# UNITED STATES PATENT AND TRADEMARK OFFICE

APPLICATION NO.	FILING DATE	FIRST NAMED INVENTOR	ATTORNEY DOCKET NO.	CONFIRMATION NO.
09/880,616	06/12/2001	Nisha D. Talagala	5181-83701	5974

# Office Action Summary

### DETAILED ACTION

**FIG. 7**

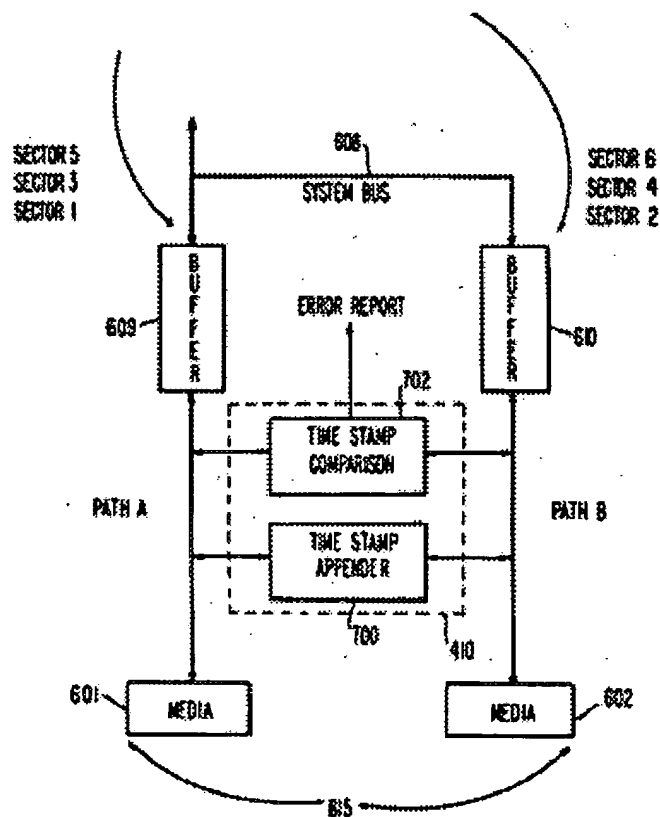
However silent error detection via parity/CRC/checksum means for RAID adequate operation is one of the desiderata of RAID design. For example, **Katz et al.**, in an analogous art, discloses RAID *architecture* in Figs. 6-7, and col. 1 line 7 – col. 18 line 16.

wherein plural fields are provided for data error checking via CRC, e.g., 3<sup>d</sup> field for RAID 310 and 6<sup>th</sup> field for RAID 504 along with means for time-stamping for tracking RAID status, e.g., device 601. Such data error checking is effected and configured for local or system-wide operation based on stimuli from either the system/extent/array controller or the local/RAID/disk controller. Corrective steps are taken in col. 6 line 35 et seq., e.g., via RS code spread across plural disks for data reconstruction in col. 6 line 62 in a manner equivalent to the claimed invention, e.g., *“a Reed Solomon coding algorithm is used to calculate the check data that is stored on the check drives. In a particularly preferred embodiment this check data is distributed across several physical disk drives in a striped manner like that of the previously described RAID level 5 architecture. A stripe comprises corresponding sectors across a set of disk drives, some of which sectors contain mass storage data and others of which sectors contain check data for the mass storage data sectors within the stripe. A stripe may be one or more sectors deep. Such stripes on a set of disks are grouped into one or more of what is hereafter referred to as redundancy groups. In this arrangement the physical devices comprising the check drives for a particular stripe varies from stripe to stripe. The widths of the stripes (i.e., the number of physical storage devices spanned by each stripe) are equal within a redundancy group.”*

**Therefore**, it would have been obvious to a person having ordinary skill in the art at the time the invention was made to modify the RAID of **Admitted prior art** by including therein silent error detection via parity/CRC/checksum means as taught by **Katz et al.**, because such modification would provide the RAID disclosed in **Admitted prior art** with a technique wherein *“The third field is the CPU data block 503 as sent from or to CPU bus or channel 319. The fourth field is a CRC code 504 appended by device controller 302 on transmission to RAID controller 310 and checked by RAID controller 310. CRC code 504 is checked again and stripped by device controller 302 on receipt from RAID controller 310. Inclusion of this field 504 allows the disk storage system to detect random data errors occurring on the bus between the device controller and the RAID controller.*
